A meeting of the **REGENERATION AND PLANNING COMMITTEE** (Quorum – 3) will be held at Myddelton House on:

- 6 **PLANNING CONSULTATION BY BROXBOURNE  
BOROUGH COUNCIL. REDEVELOPMENT OF  
LAND AT DELAMARE ROAD TO PROVIDE A  
RESIDENTIAL-LED MIXED-USE DEVELOPMENT  
COMPRISING 471 RESIDENTIAL UNITS AND  
ANCILLARY RESIDENTIAL FLOORSPACE; UP  
TO 2436 SQM OF NON-RESIDENTIAL  
FLOORSPACE INCLUDING OFFICE (CLASS E(G)(I)  
LIGHT INDUSTRIAL (CLASS E(G)(III) LEISURE  
(CLASSES E(D) AND SUI GENERIS), COMMUNITY  
(CLASS E(E)-(F) AND CLASS F1)) FLOORSPACE  
AND RETAIL (CLASS E(A)(B)(C)) A NEW LOCAL  
CENTRE, PLAZA, LANDSCAPING, CAR PARKING,  
CYCLE PARKING, PEDESTRIAN CYCLE AND  
VEHICULAR ROUTES AND ASSOCIATED WORKS.  
REF: 07/22/0597/F PARCELS 12 & 13 LAND AT  
DELAMARE ROAD CHESHUNT EN8 9AP.** Paper RP/60/22

- 7 **PLANNING CONSULTATION BY THE BOROUGH  
OF ENFIELD. DETAILS OF RESERVED MATTERS  
(SCALE, LAYOUT, ACCESS, EXTERNAL  
APPEARANCE AND LANDSCAPING) FOR 274  
UNITS IN RESPECT OF PLOT Z02-01 WITHIN  
BUILDINGS FROM 10 TO 16 STOREYS IN HEIGHT  
PURSUANT TO CONDITION 4 OF OUTLINE  
PLANNING PERMISSION 19/02718/RE3 DATED  
31ST MARCH 2022 FOR DEVELOPMENT OF  
PHASE 2 OF MERIDIAN WATER CO

Fig 02: Perspective view

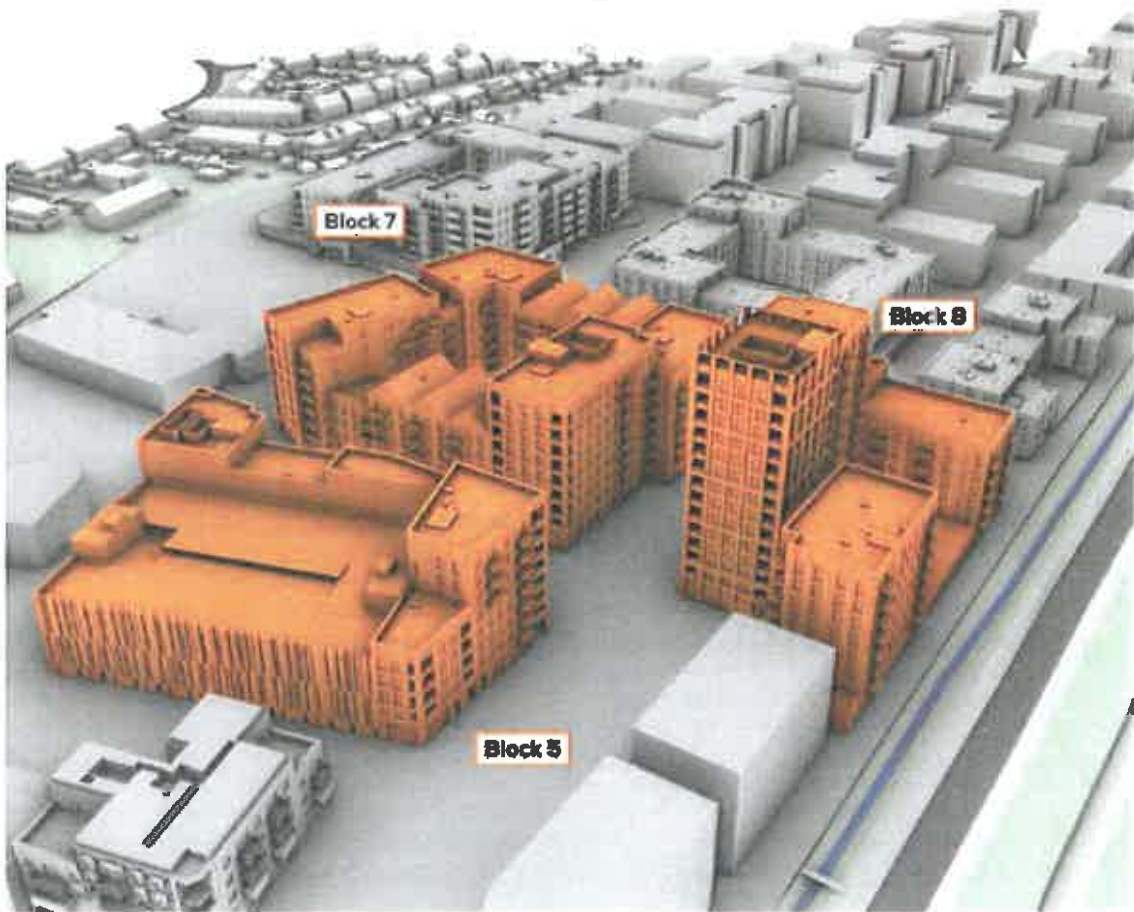
The scale and design of certain elements of the proposed development, located close to the Regional Park boundary, are considered to have a negative impact on the Park, its landscape and ecology and the recreational amenity of visitors. They introduce a step change in the scale of built development adjacent to the Regional Park and potentially set an uncomfortable precedent for future phases of Cheshunt Lakeside. An objection is therefore proposed to the application and a reduction in height sought to the proposed 14 storey building in Phase 12.

The proposed development incorporates a number of building typologies and a material strategy that responds to the proposed street character and principles already established through the masterplan. The 14 storey building within Block 8 (Parcel 12) is designed as a 'landmark' building to act as a marker for the public plaza on the approach from the station. The double height base of the building aims to elevate it from the adjoining 'civic' buildings, and it has a light

- 27 It is also likely that the height and design of both the 14 and 8 storey buildings close to and overlooking the buffer planting, railway and wooded Park could impact upon biodiversity in terms of light pollution and general disturbance. Bolt

**Appendix C Building Types and Heights**

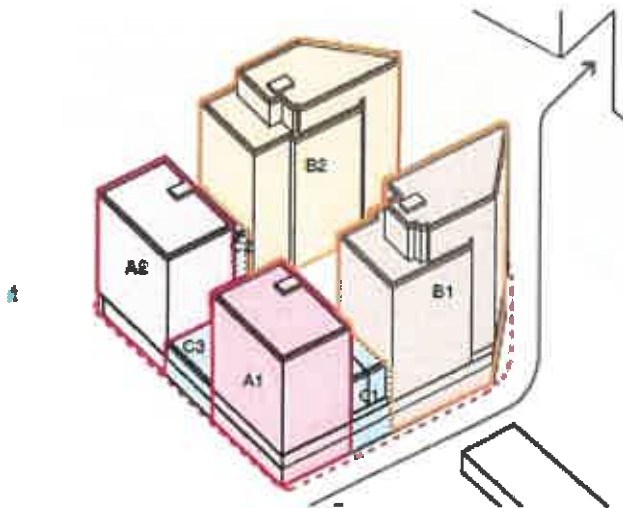
Park at Tottenham Marshes. The outline approval has set the parameters for the height and overall scale of development within this plot and the design code has informed the detail of the scheme. Whilst the development is of high quality and seeks to create an attractive frontage to the new Brooks Park its layout, massing and landscape does not achieve a successful interface with the Regional Park
